ADDENDUM NO. 2 - OUTLINE AND SUMMARY INFORMATION

Project Name: PARKING IMPROVEMENTS 2025 PPA No.: 22-0012
Location: GRANT CHAMBERLAIN, Bozeman, MT 59717 Date: 10-22-2024

B E-BLOCK
C5-4 NTS

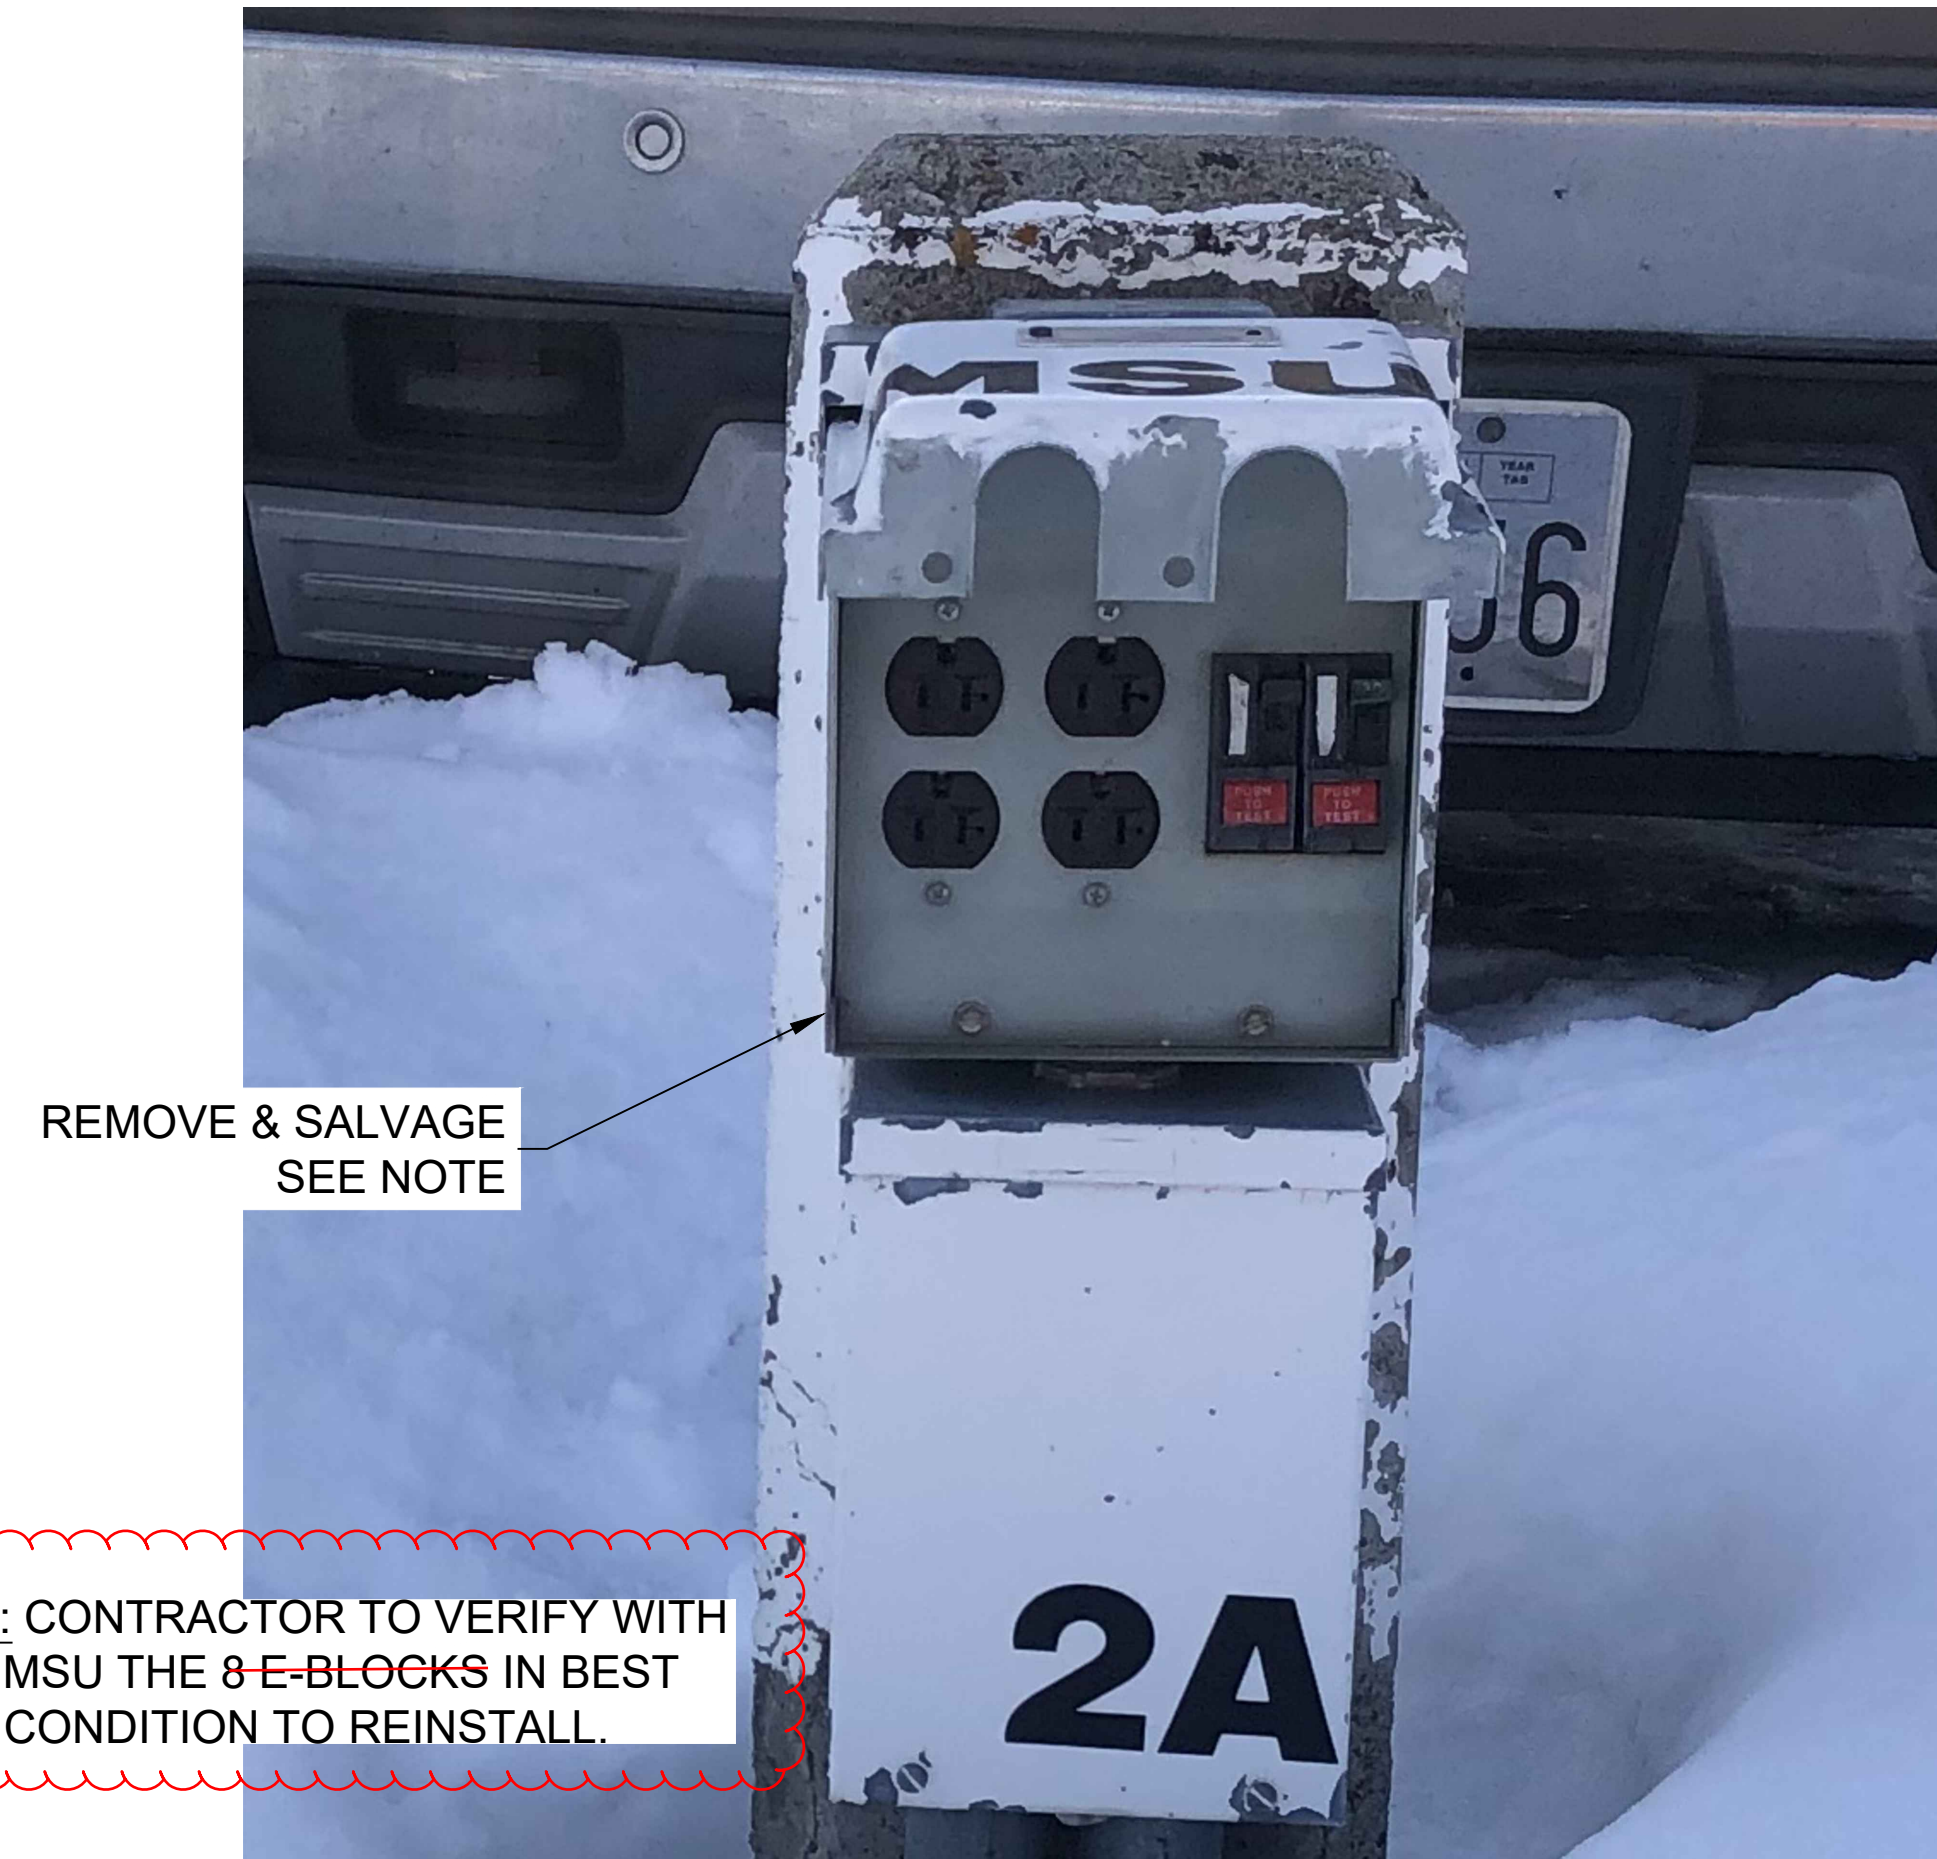
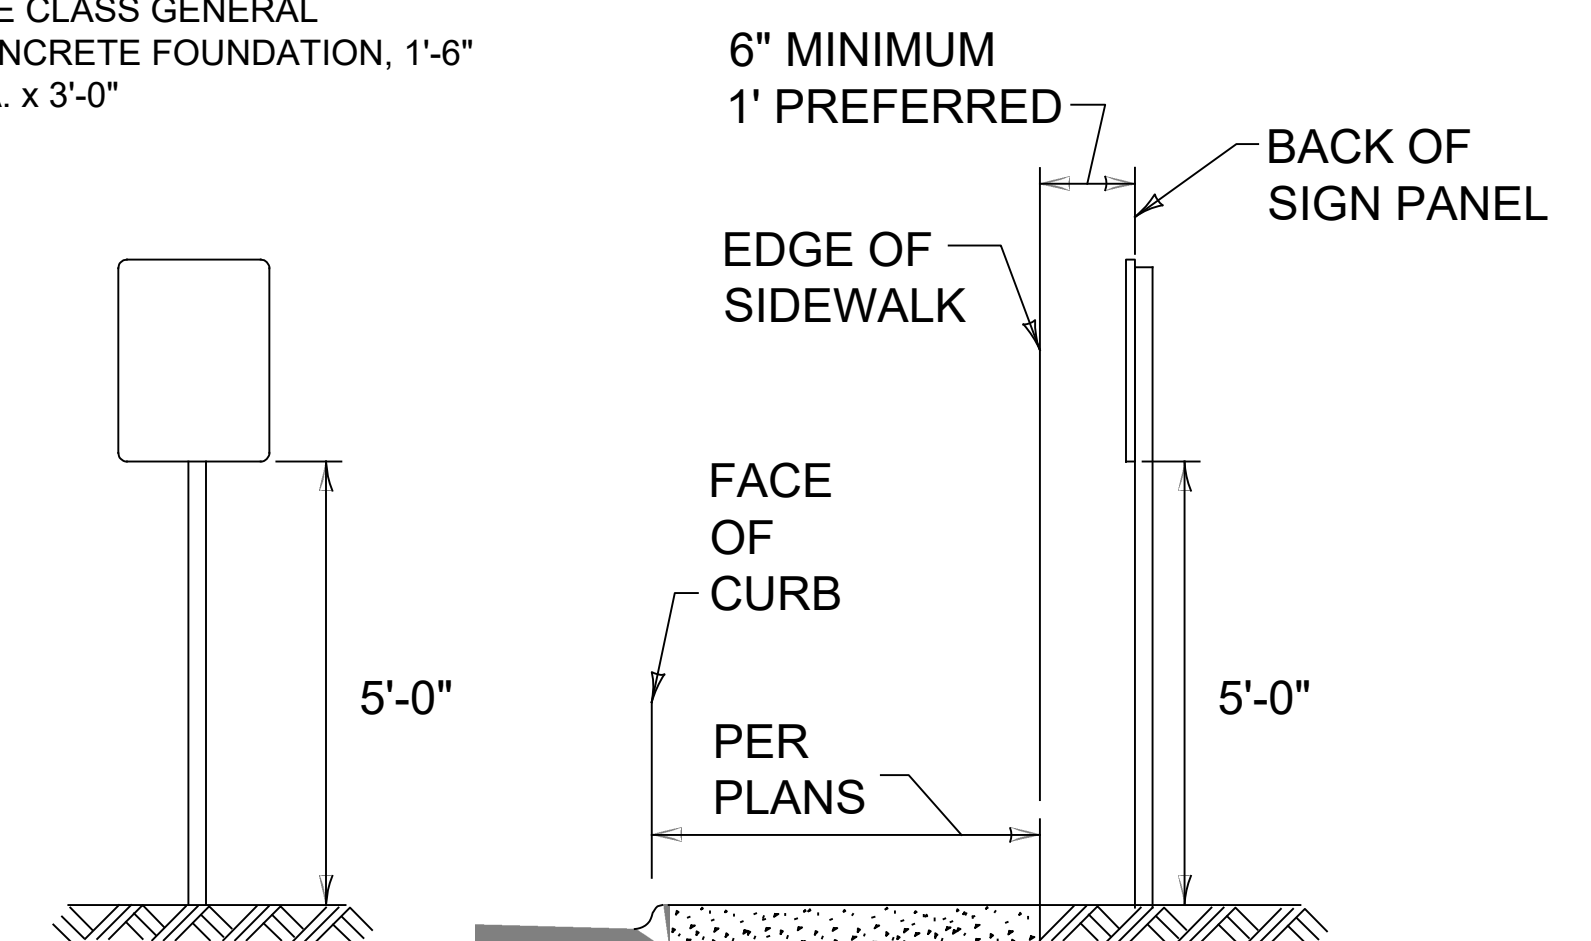
B. **SHEET C5-4**

REPLACE “8 E-BLOCKS” with “4 E-BLOCKS” in DETAIL B/C5-4. There will only be 4 electrical blocks to be reinstalled for Grant Chamberlain.

4 E-BLOCKS FOR REINSTALL

SHEET
C5-5

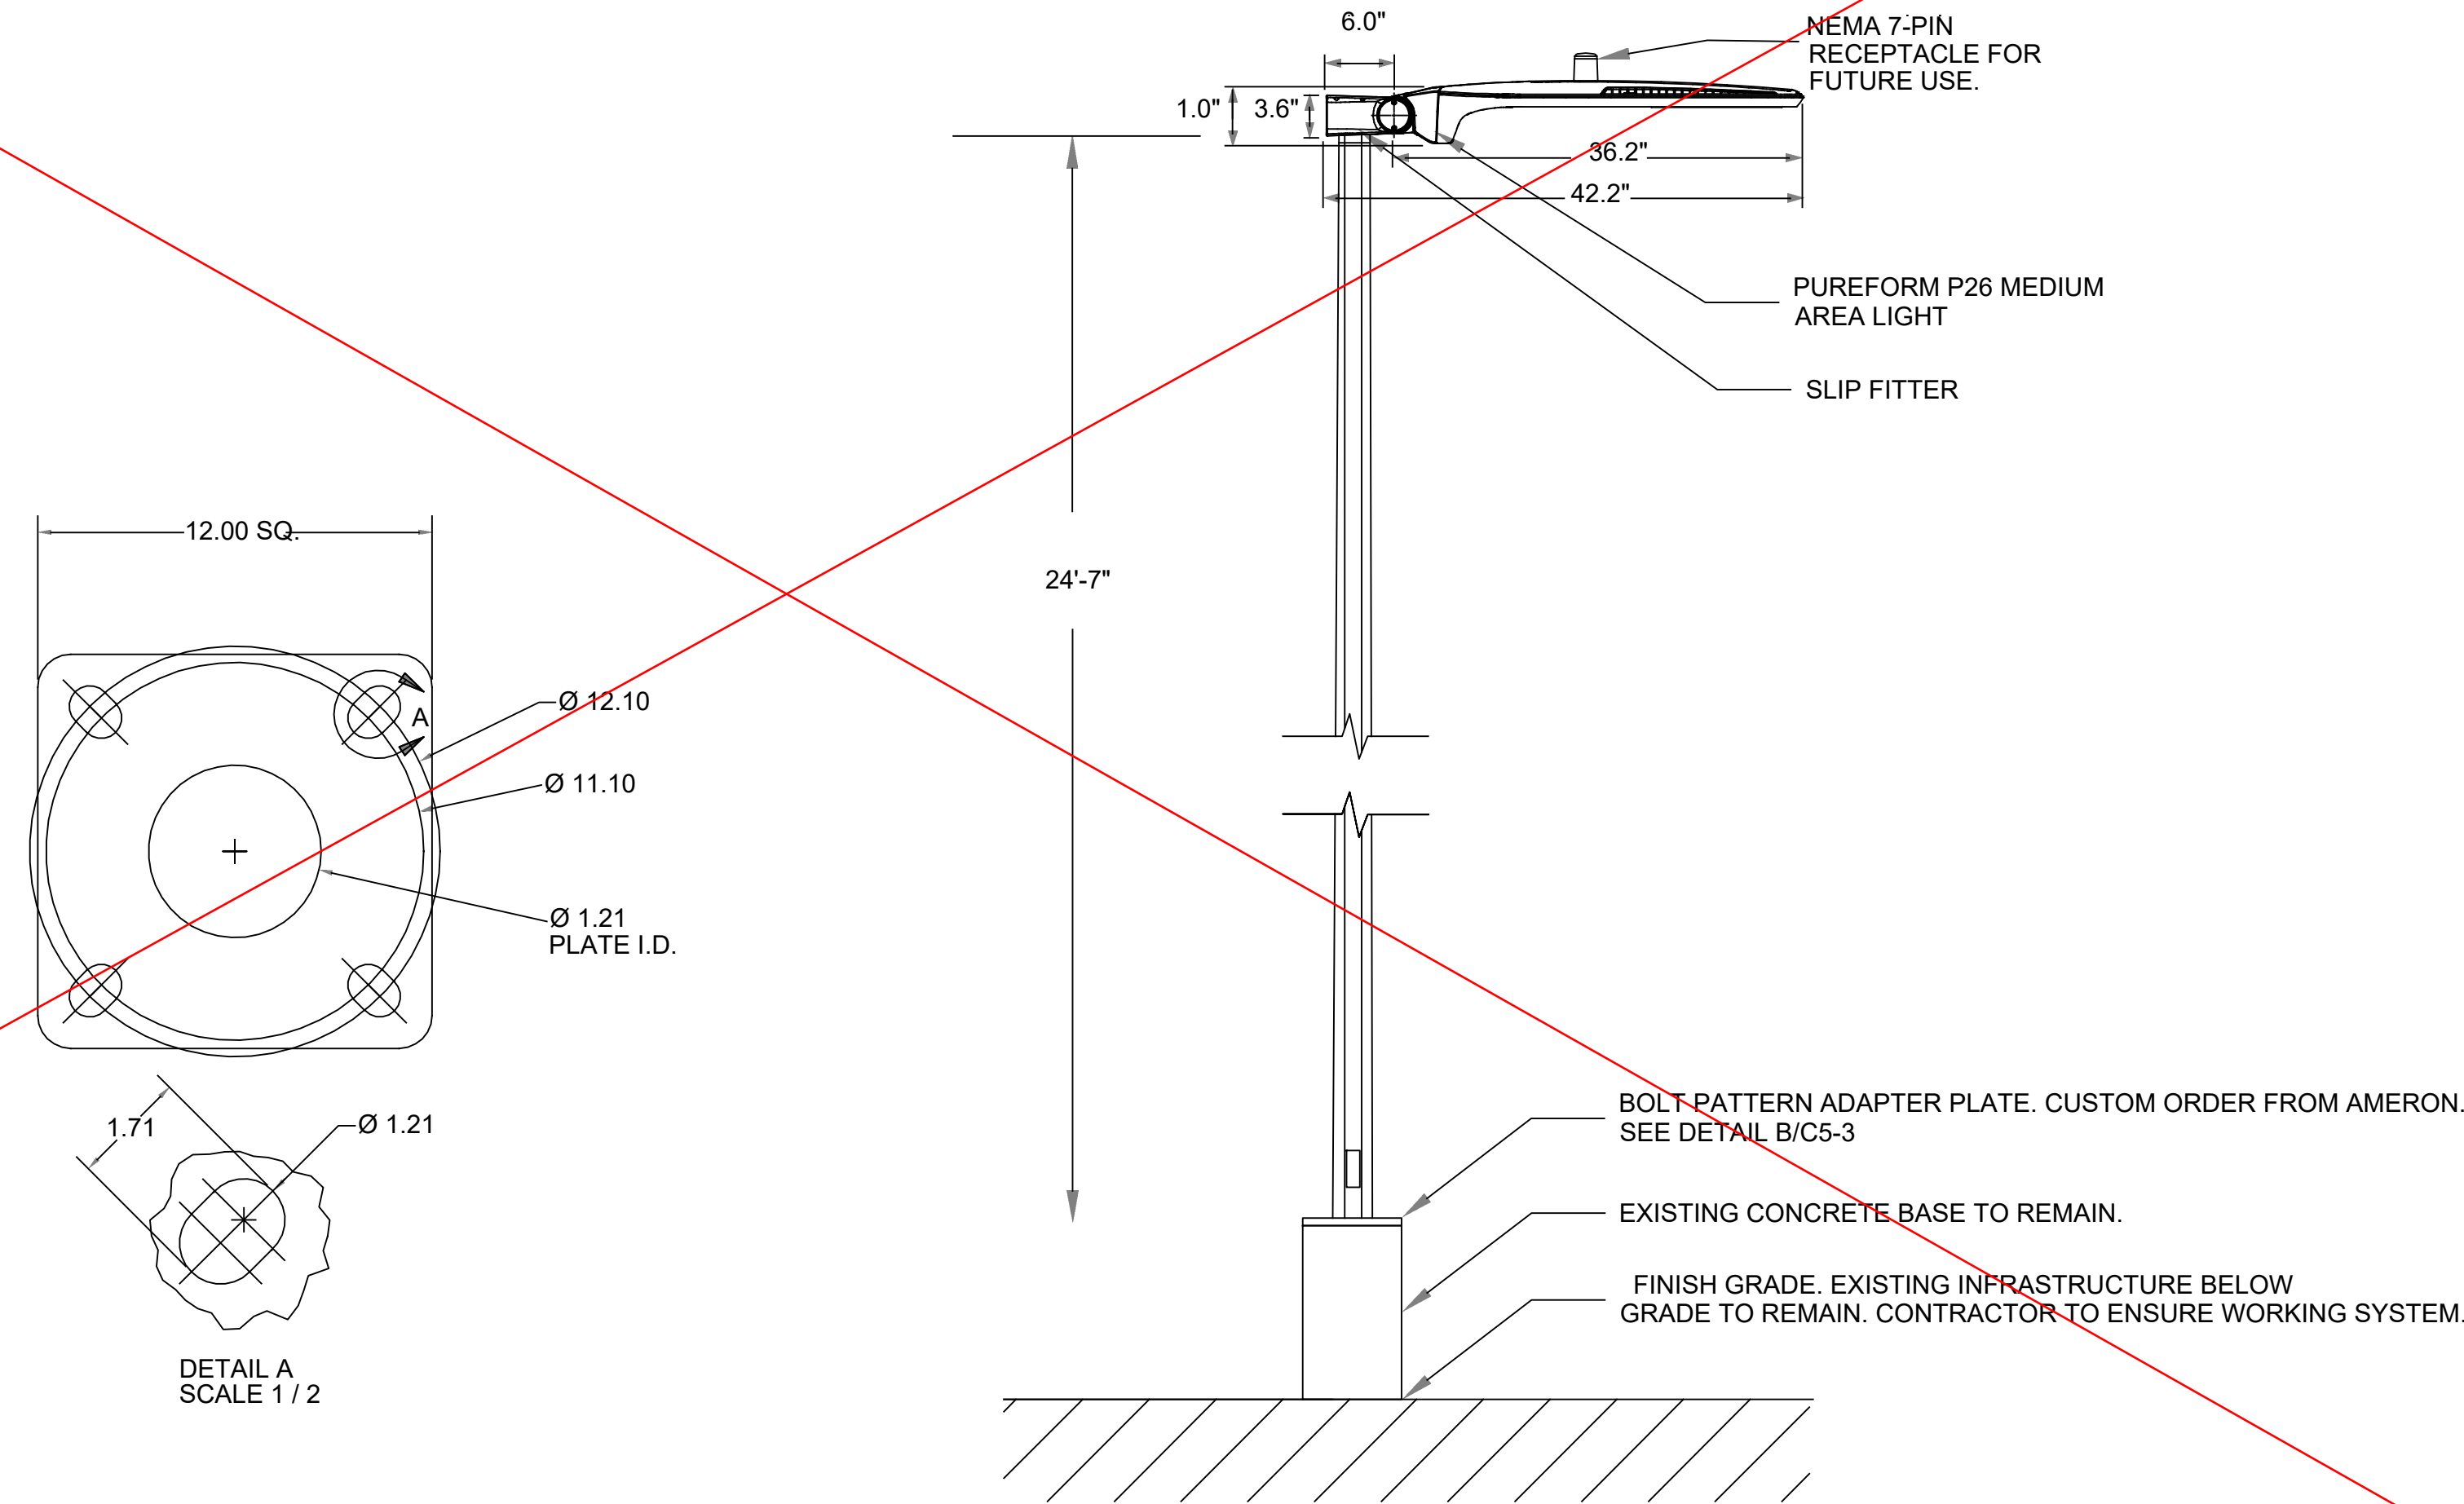
C. **SHEET C5-5**

DELETE SHEET C5-5. There will be no light poles removed or replaced with Grant Chamberlain.

NO LIGHT POLE REMOVAL OR REINSTALLATION NECESSARY FOR GRANT CHAMBERLAIN
